DEPARTMENT OF THE ARMY TECHNICAL MANUAL

**ARMAMENT SUBSYSTEM,
HELICOPTER, 7.62 MILLIMETER
MACHINE GUN: HIGH RATE,
XM27E1 (1005-933-6242) (USED ON
OH-6A HELICOPTERS)**

**This copy is a reprint which includes current pages from Changes 1
through 3**

TM 9-1005-298-34, 30 July 1969, is changed as follows:

Figure 1-1. (Superseded) Components of Armament Subsystem.

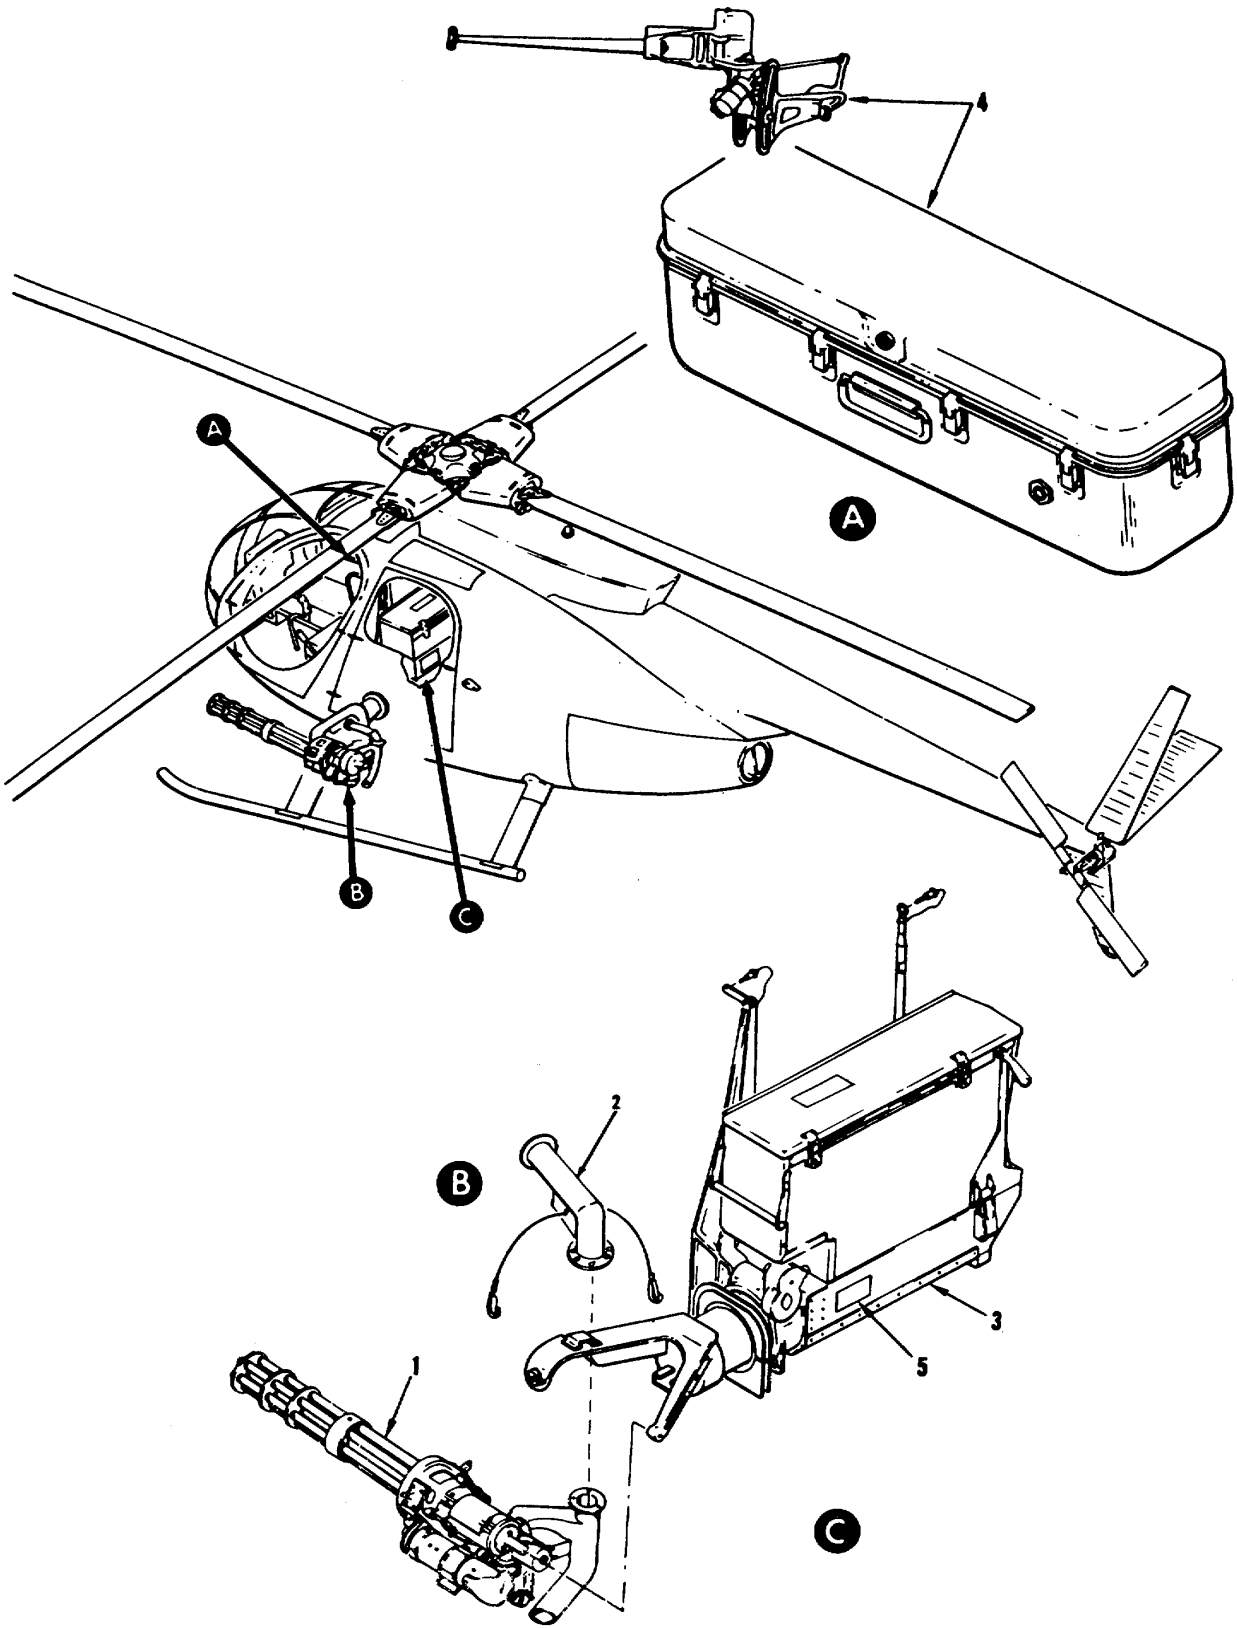
Delete figure 1-1, WE 15616A, and substitute figure 1-1, WE 67170, Components of Armament Subsystem XM27E1.

Figure 3-3. (Superseded) Bolt Assembly-exploded view.

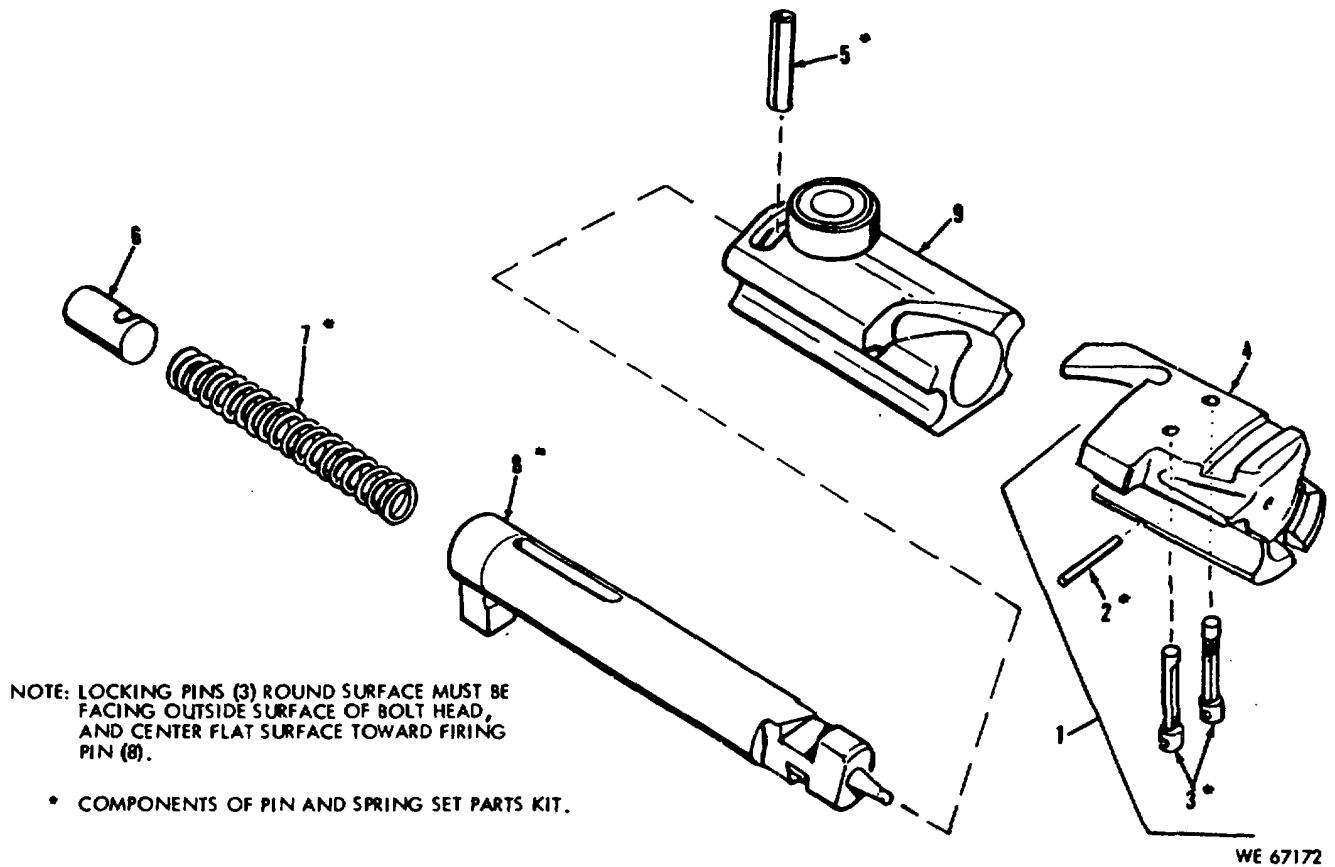
Delete figure 3-3, WE 61488, and substitute figure 3-3, WE 67172, Bolt Assembly-exploded view.

Figure 4-1. Ram air duct assembly-exploded view.

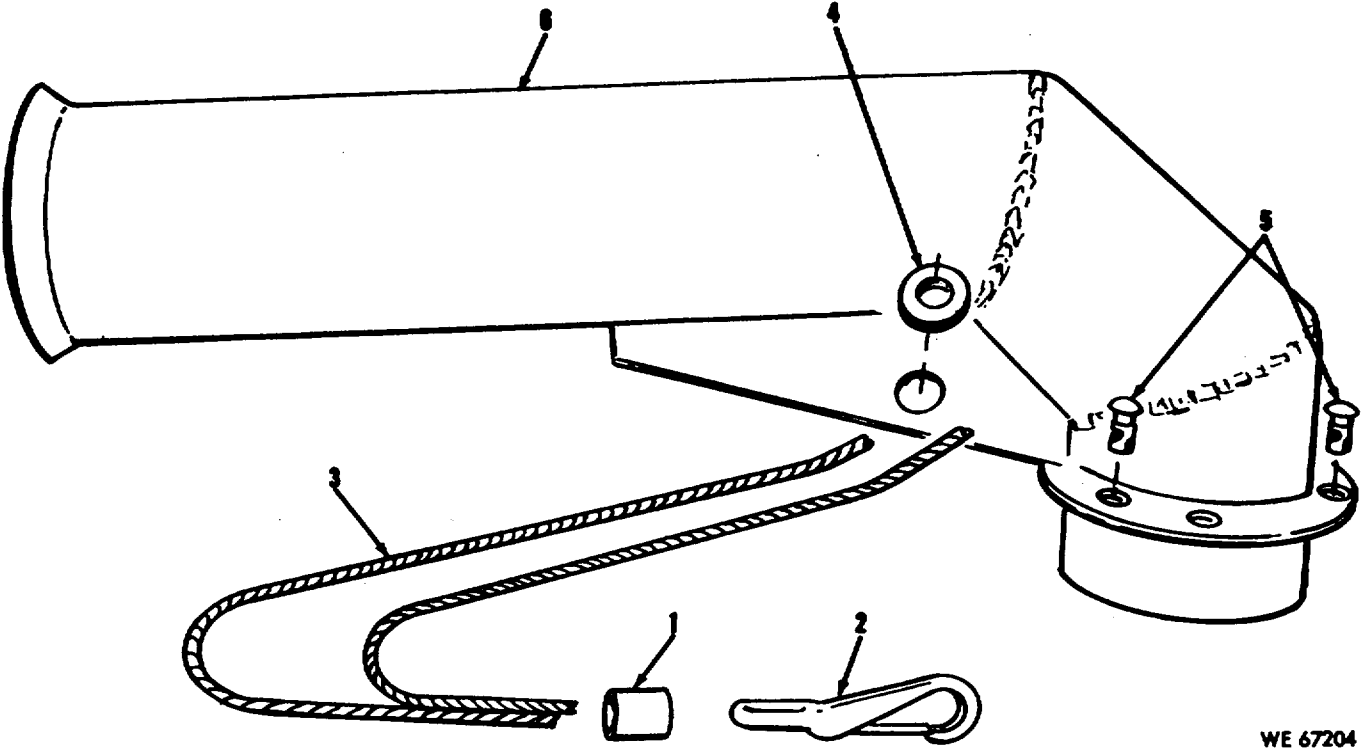
CHAPTER 4 (SUPERSEDED) REPAIR OF RAM AIR DUCT ASSEMBLY

See figure 4-1. Limit disassembly to removal of faulty parts such as fasteners, retaining cable, and rubber grommet.

- Cleaning. Refer to paragraph 2-9a and apply procedures used for cleaning mount assembly parts.
- Inspection. Check for damaged fasteners, frayed or broken retaining cable, and for torn or missing rubber grommet.
- Repair. Replace excessively worn, broken, or missing parts using standard shop procedures and tools.

Figure 5-8 (Superseded) Tube Assembly-partially exploded view.

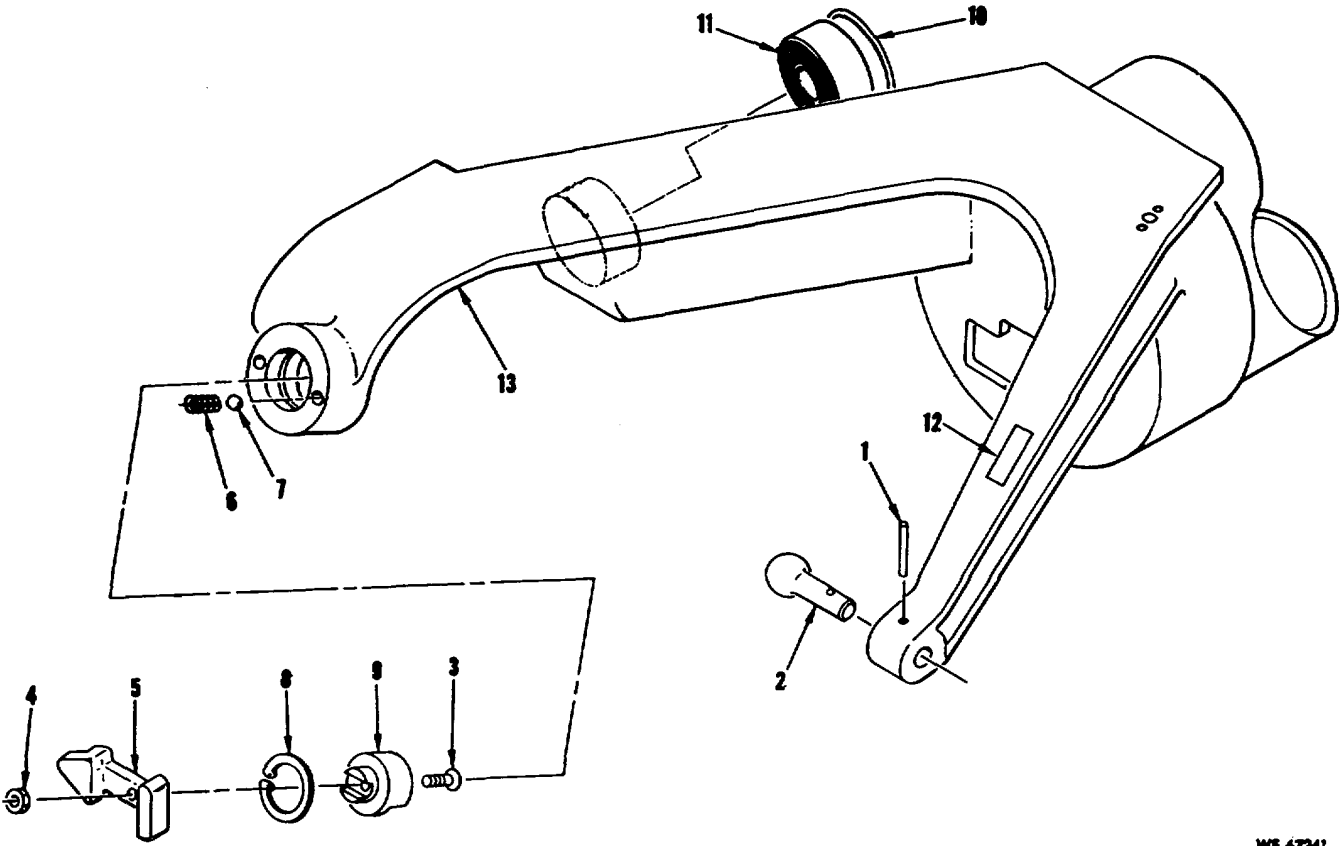
(4) (Superseded) Check tube assembly parts including resilient mount (11, fig. 5-8), bolt ball (2), and camlock (9) for excessive wear or damage.

Delete figure 5-8, WE 15607, and substitute figure 5-8 WE 67241, tube assembly-partially exploded view.

Delete the key for figure 5-8, WE 15607, and substitute the following key for figure 5-8, WE 67241:

Figure 6-4 (Superseded) Reticle project assembly—partially exploded view.

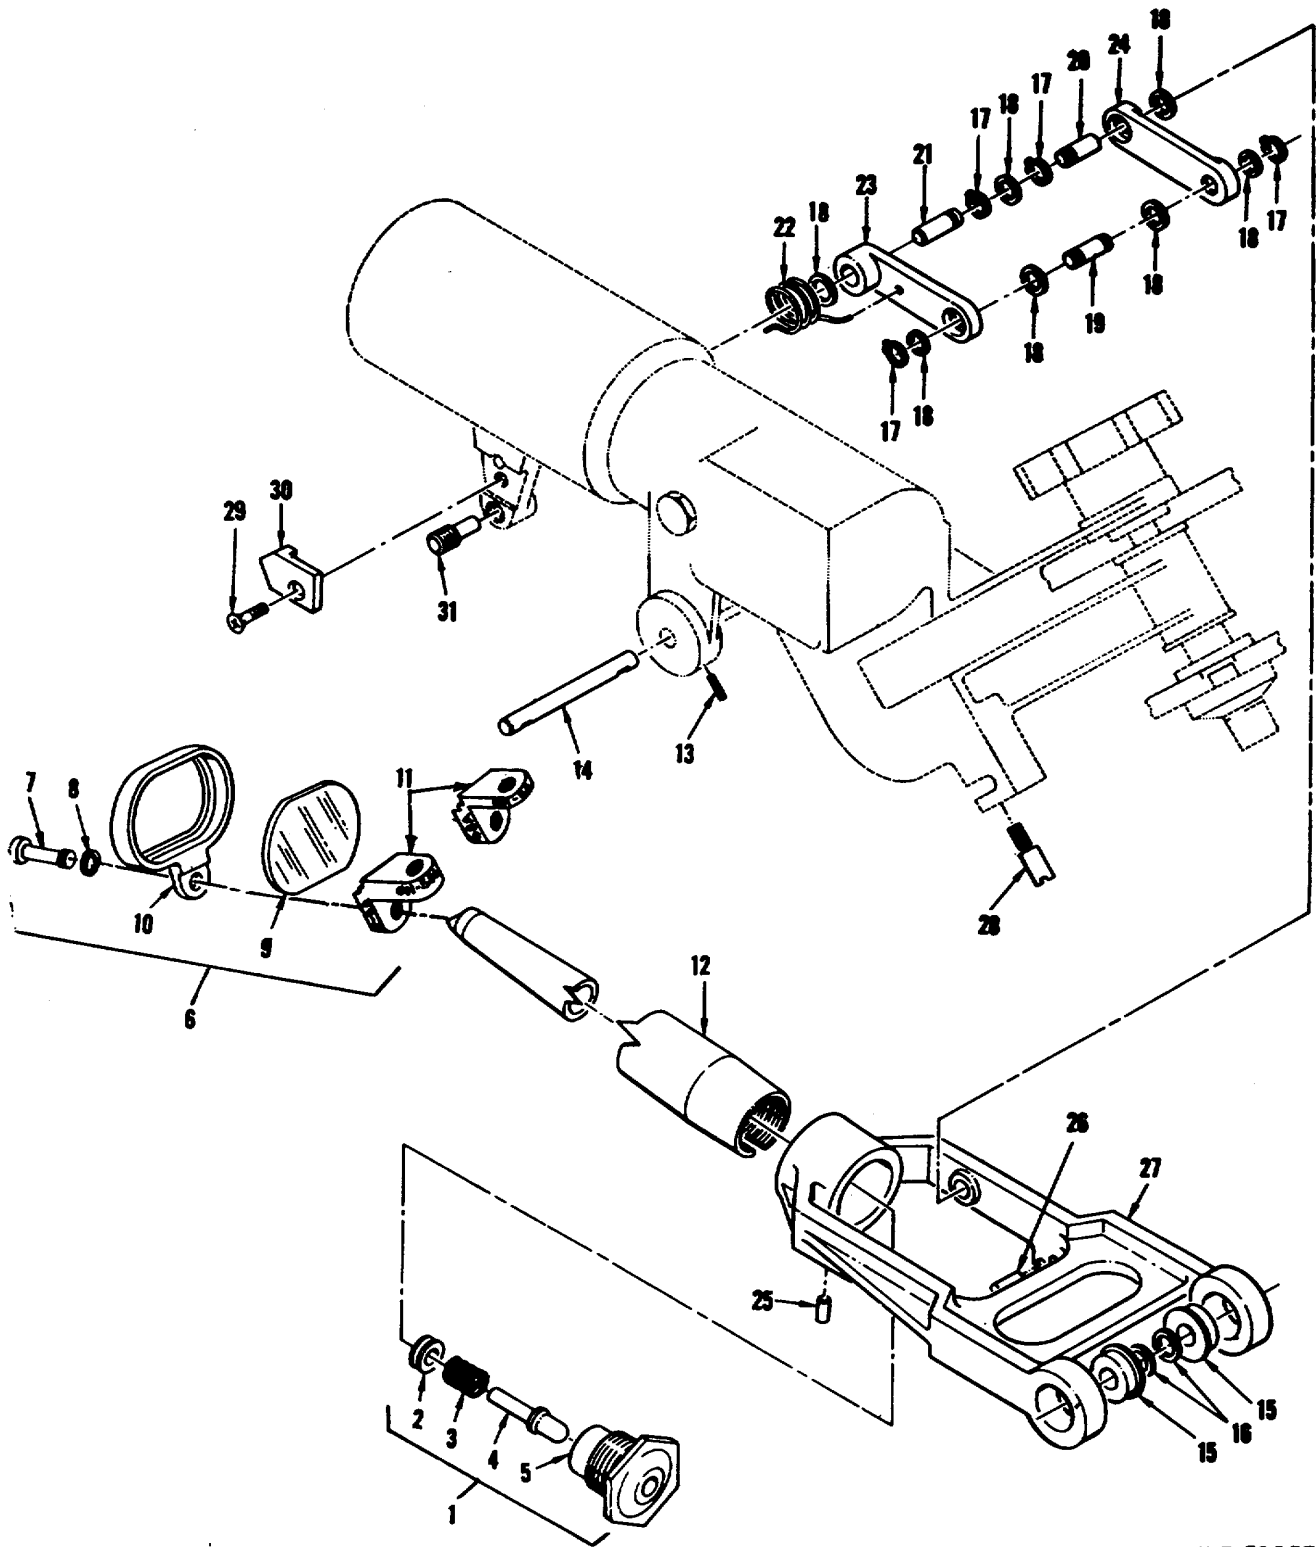
Delete figure 6-4, WE 15615, and substitute figure 6-4 WE 52857, Reticle project assembly-partially exploded view.

Delete key for figure 6-4, and substitute the following:
